uEZGUI-1788-43WQR Product Change Notification Form

PCN Number: 20140523-01	Rev: 7.2	Date: 05/23/2014
-------------------------	----------	------------------

Summary of Change: uEZGUI-1788-43WQR-BA Functional Test code update with Bootloader demo

Rev 7.1 Boot Screen: (straight into menu)

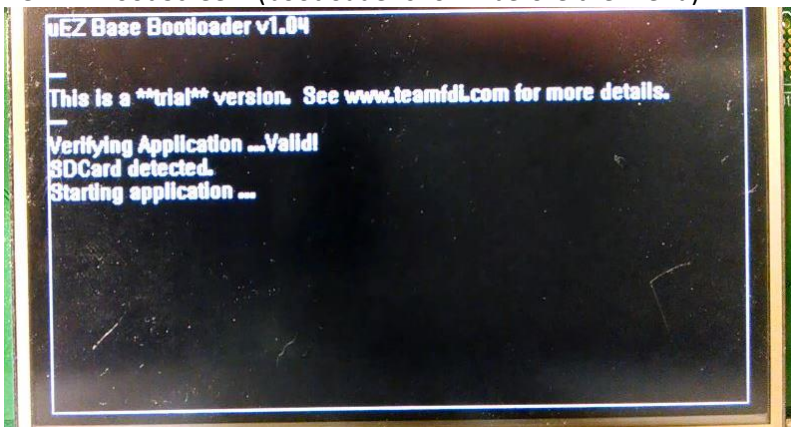
As a result of this revision, the uEZGUI-1788-43WQR-BA Boot Screen will change as shown below:

Rev 7.2 Boot Screen: (bootloader shown before the menu)
